CUSTOMER TECH MEMO # 500

Subject *Versastyle Classic Wardrobe Systems – TM Update of Head Guide and Cutting Formula*

Date: 24th November 2021

VS HEAD GUIDE L/H & R/H

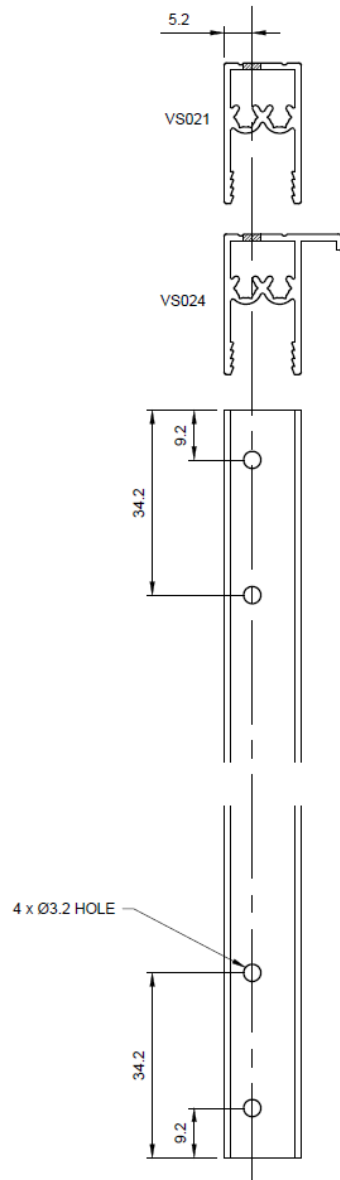
- Extrusions updated to include VS006 on page 5.5
- Typical Details cutting formula updated on page 8.1 – 8.9
- Cutting Formula for stiles and rails updated on page 9.1 – 9.5
- Update of Manufacturing Details for rail on page 10.3 to include same machining for roller and head guide, please refer to the image on the next page. The head guide has been updated to allow for the same rail machining as the machining for the roller. The head guide part number and description has remained the same
